SUBJECT: LAKESIDE DRIVE INFRASTRUCTURE IMPROVEMENTS

CITY OF JACKSONVILLE
DEPARTMENT OF PUBLIC WORKS
ENGINEERING DIVISION
CONSTRUCTION CHANGE ORDER

Change Order No. One (1) Date July 9, 2020

Description of Project Lakeside Drive Infrastruture Improvements

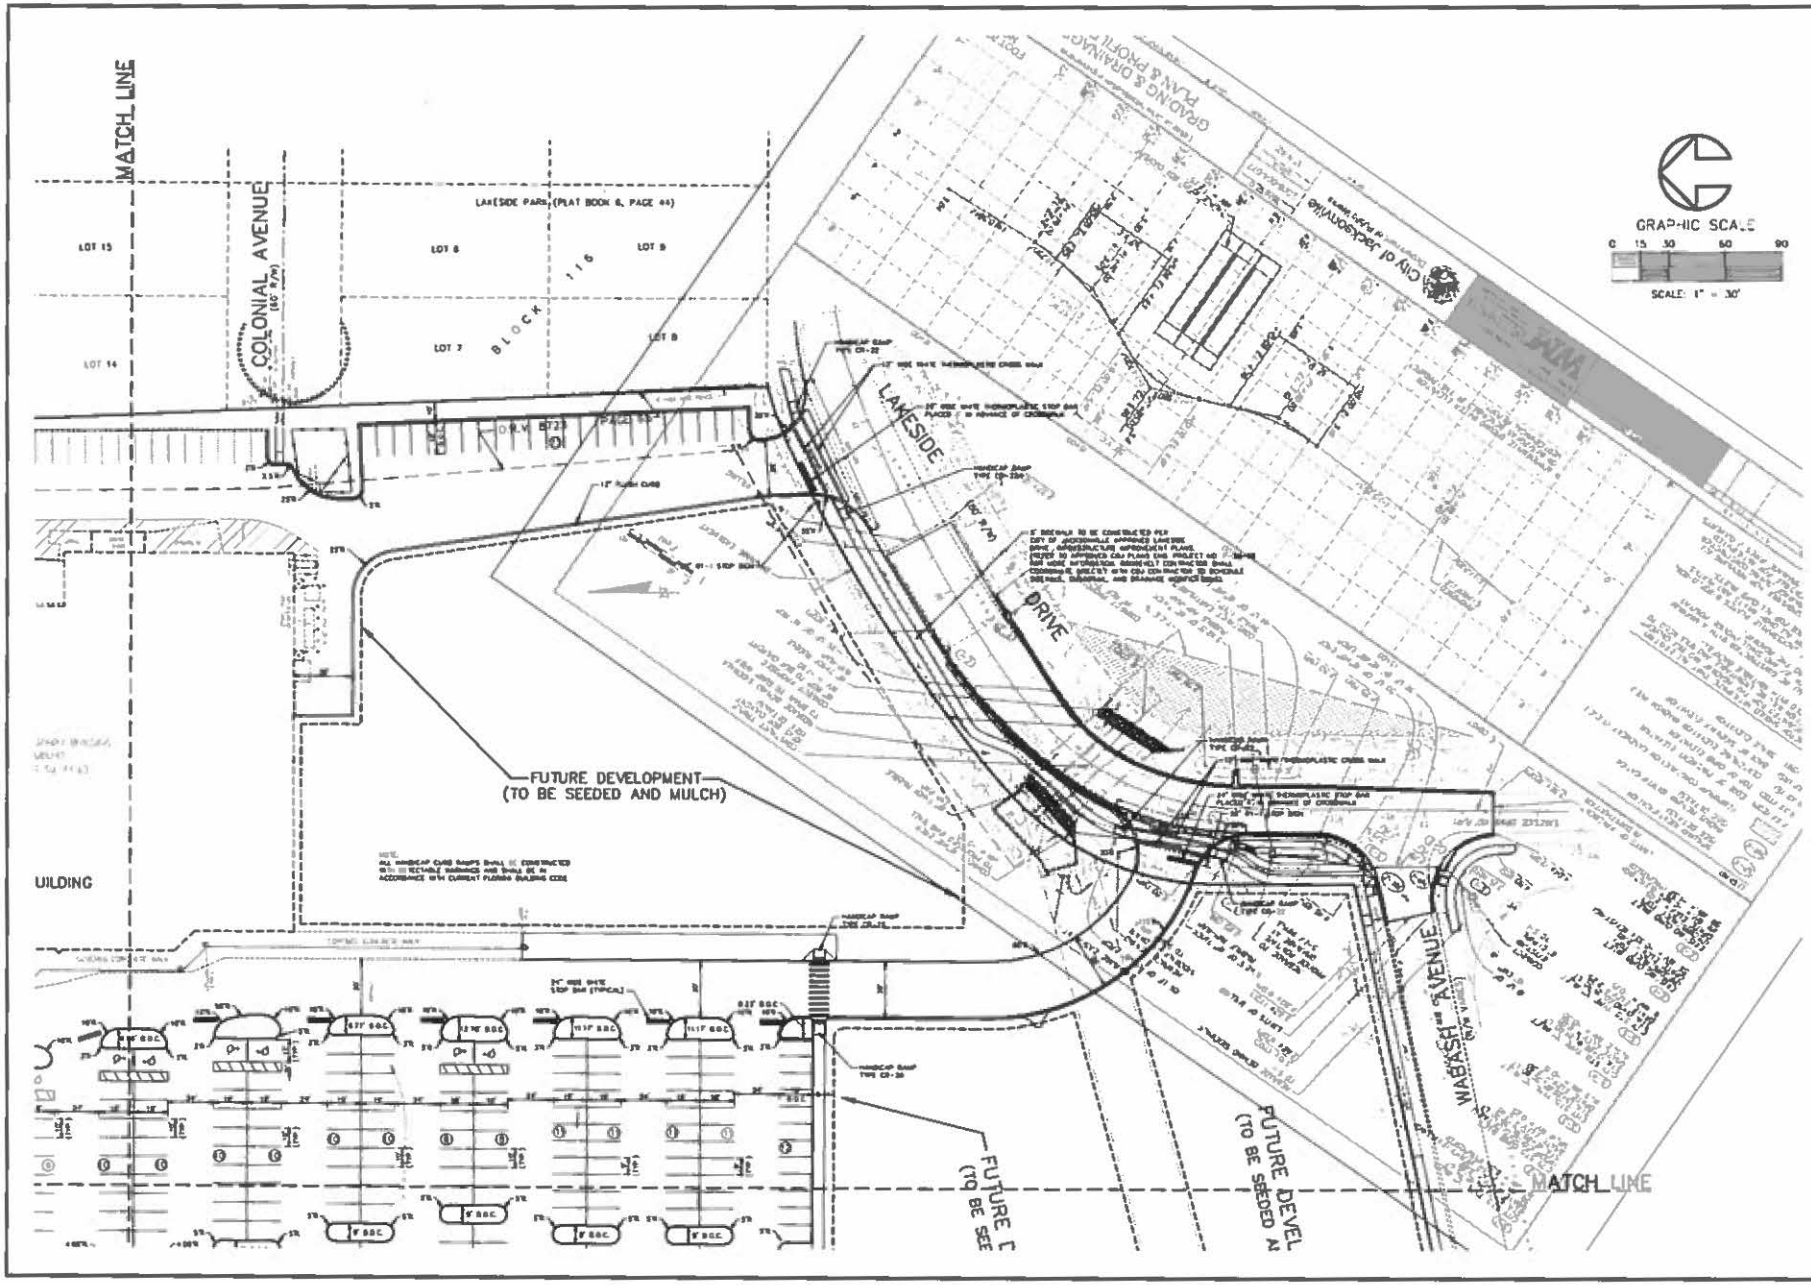
JUSTIFICATION: The adjacent Roosevelt Square developer obtained a COJ permit to construct two turnouts within the project limits. These turnout additions will be constructed at the Roosevelt Developer's cost. These changes will result in a reduction in sidewalk, curb, and guardrail work on the COJ's project where the turnouts will be constructed.

Roosevelt Square Turnout Changes

SOV Item No.	Item Description	Unit	Unit Price	Quantity Change	Cost Change
190	Sidewalk, 4" Thick	SY	$ 36.50	-47	$ (1,715.50)
180	City Standard Curb & Gutter	LF	$ 21.00	-157	$ (3,297.00)
210	Guardrail	LF	$ 113.00	-56	$ (6,328.00)
Total					**$ (11,340.50)**
